FOUNDATION INVESTIGATION REPORT

W.P. 827-73-02 Site No. 15-120
Hwy. 43, District 8, Kingston
Widening of Bakers Bridge (Rosedale Creek)
5.7 Miles West of Rideau Canal Bridge
at Merrickville

Rosedale Creek
Bakers Bridge Widening
W.P. 827-73-02, Site 15-120
Hwy. 43, District 8, Kingston

Rosedale Creek
(Baker's Bridge) Widening
W.P. 827-73-02, Site 15-120
District 8, Kingston

TYPICAL GABION WALL SECTION

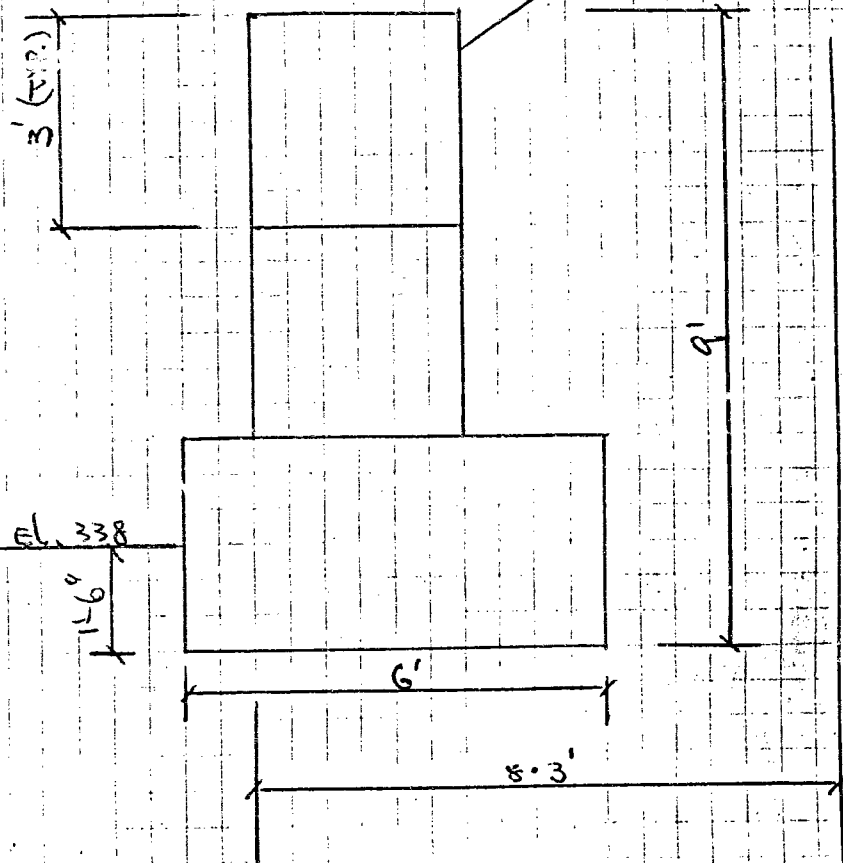
1. The total additional dead load which will be applied on the existing bridge is approximately 45 kips.
2. The proposed gabion wall cross-section (maximum height 9'), is indicated on the attached sketch.

- a) A further evaluation of the magnitude of differential settlement between the existing structure which is supported on spread footings and the widening which will be supported on piles, and
- b) A review of the stability of the north embankment slopes.

1. The additional loading of 0.6 ksf imposed on the existing footings due to an increased deck elevation is considered acceptable.
2. Under this new loading, the existing structure may settle an additional 0.5 inches. In view of this, construction joints should be provided to accommodate the differential settlements.
3. The gabions on the north bank are found to be stable.
4. Pile lengths of the west abutment could be reduced to 32 feet.
